ACER Workshop on the Network Code for Requirements for Grid Connection applicable to all generators

Ljubljana
03 September 2012

Table 5: Parameters for full activation of Active Power Frequency Response resulted from Frequency step change (explanation for figure 6).

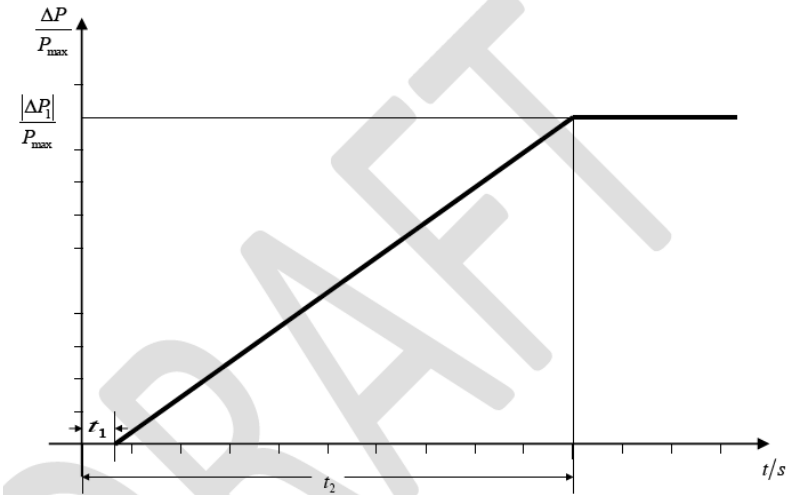
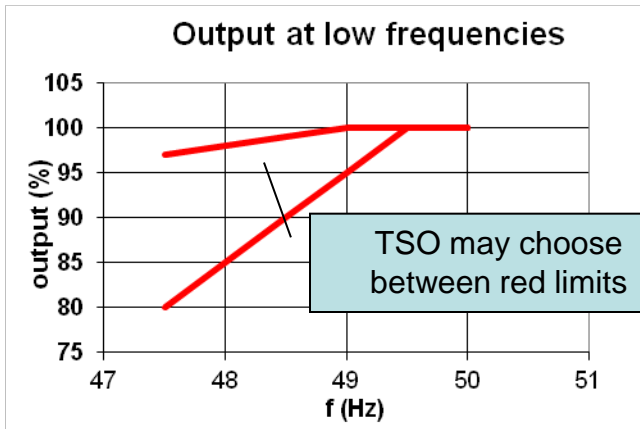
- Full activation time is « maximum » 30 sec... but it can be lower!
- Impact on machine design – lower time frame may be difficult to achieve
- Decision is left to TSOs... without guidance or limitations (Art. 7 ...” introduce [...] more detailed or more stringent provisions”)

GT power output (typical – without compensation)

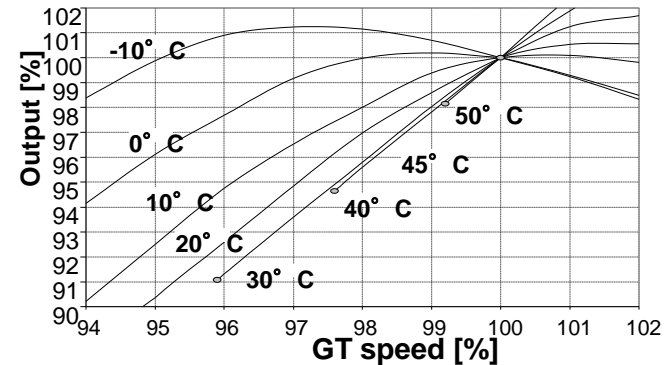
- Goal.. Not to get power imbalance worst
- Remain connected is not the only prime focus ...Require to maintain residual power above a given limit

- Reduce speed...reduce power
- Handling requirement in the past:
 - Compensation features: increase firing temperature, open inlet guide vanes, inject steam or water in the compressor...may take more than a few seconds to react...
 - Limited in ambient temperature (25° C UK –driven)
- **Limitations...compressor surge limits, firing temperature**
